## **REMARKS/ARGUMENTS**

**Amendments to the Drawings:**

FIG.3

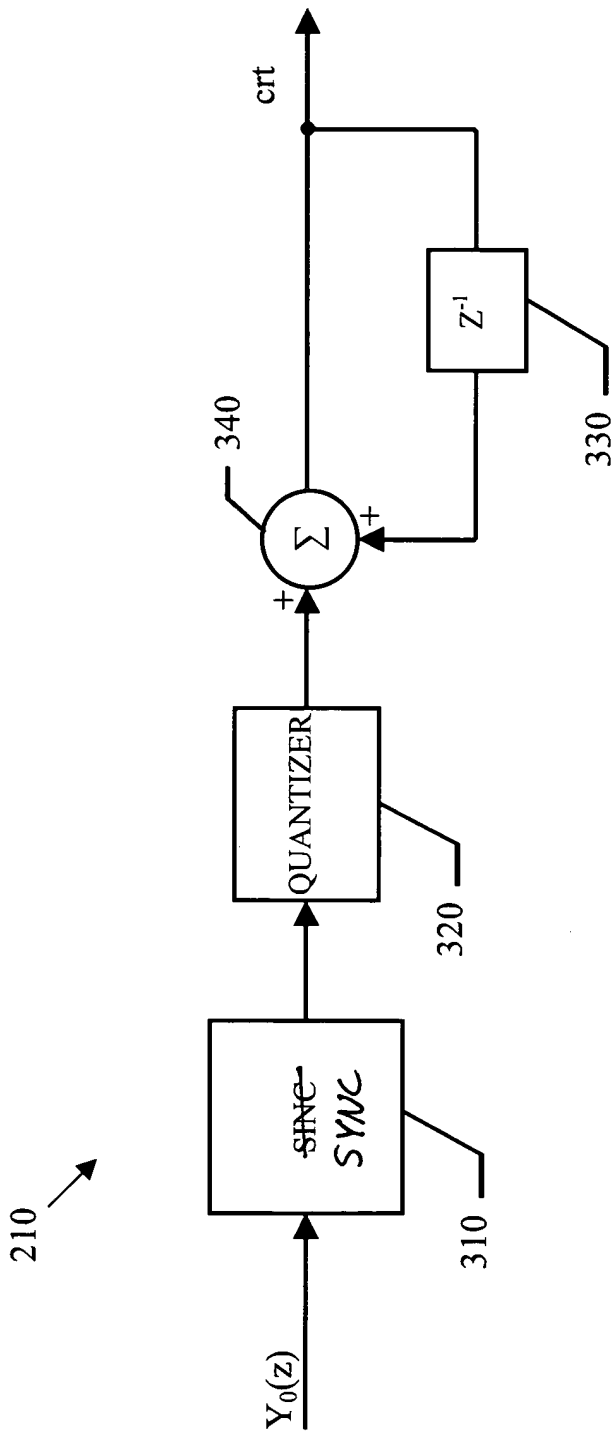
The attached sheets of drawings includes changes to FIGs. 3 & 4. These sheets, which include FIGS. 3 & 4, replace the original sheets. In Figure 3, the word "Sinc" in block 310 has been amended to read "Sync." In Figure 4, the reference number 411 has been added to identify the ellipses shown in the drawing.

FIG.4

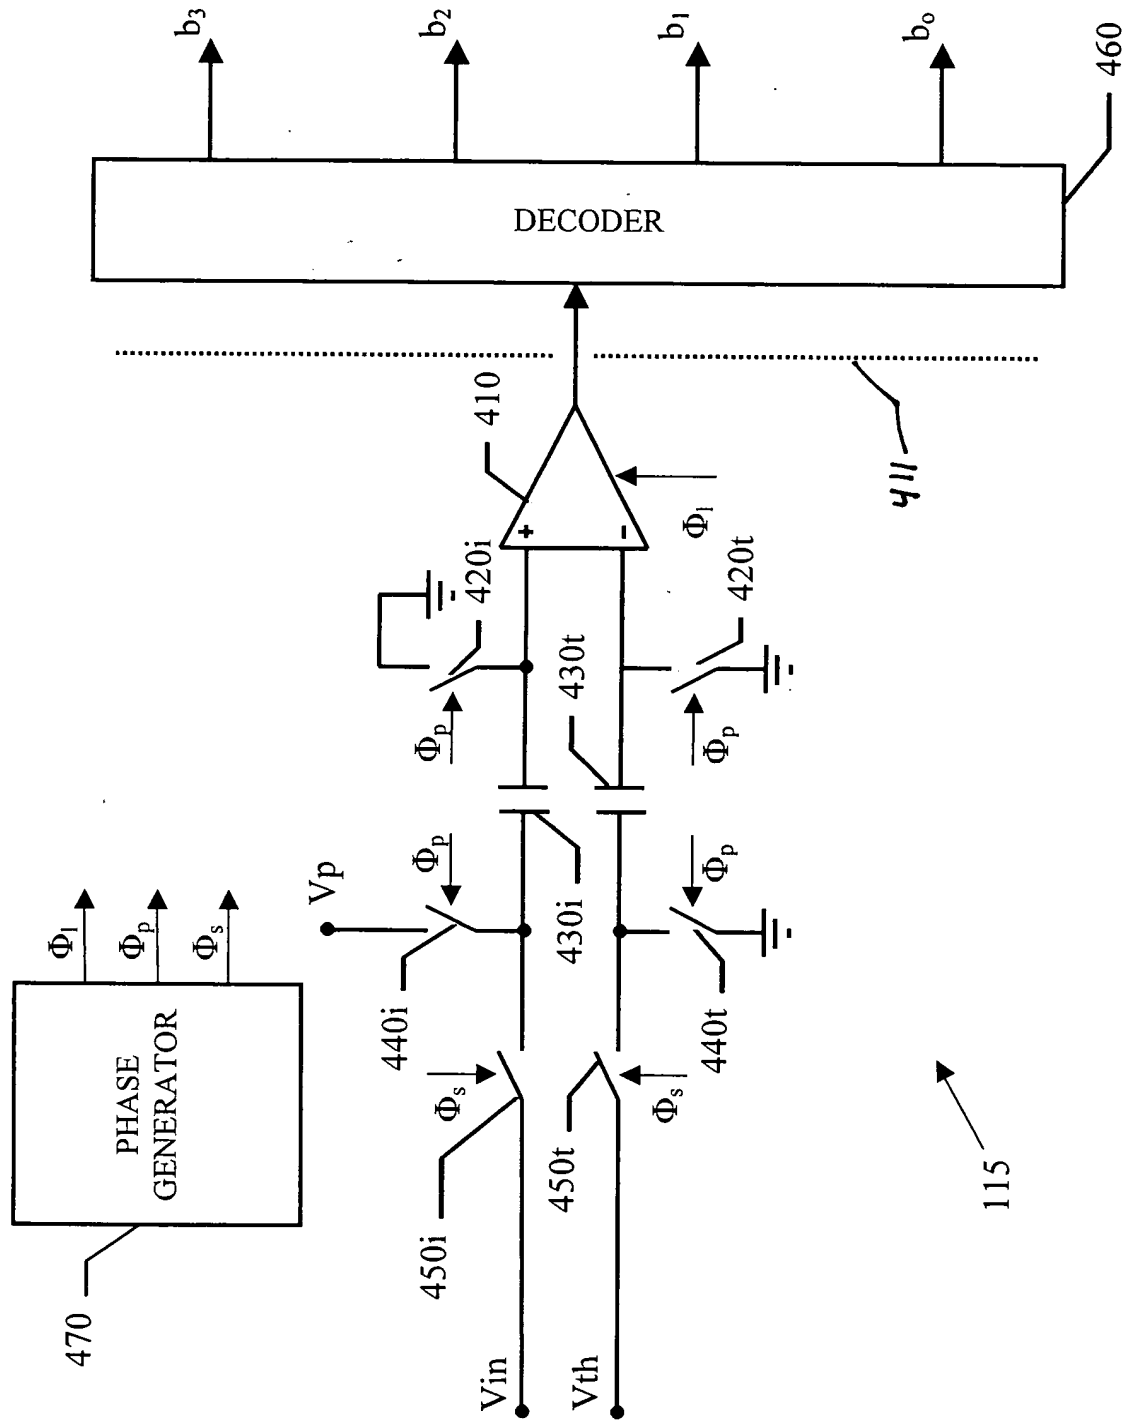
On page 2 of the Office Action, the Examiner requests that FIG. 4 be marked as Prior Art. Applicants respectfully disagree that the FIG. 4 is Prior Art. FIG. 2, which shows a preferred embodiment to the present invention, includes ADC 115. FIG. 4 simply shows a detailed view of inventive element 115, as used in the preferred embodiment, which is shown with multiple inputs, as well as the phase generator 470. It is therefore submitted that the ADC 115, as shown in FIG. 4, is not prior art and the Examiner's objection should be removed.

On page 2 of the Office Action, the Examiner requests that FIG. 4 be amended to show a plurality of comparators 410. FIG. 4, as originally filed, included an ellipsis above and an ellipsis below the comparator 410 indicating a plurality of comparators. FIG. 4 has been amended to identify the ellipses by identification number 411. In addition, the paragraph starting on line 1 of page 14 has been amended to explain that the ellipses are intended to represent a plurality of comparators. It is therefore submitted that the Examiner's objection should be removed.
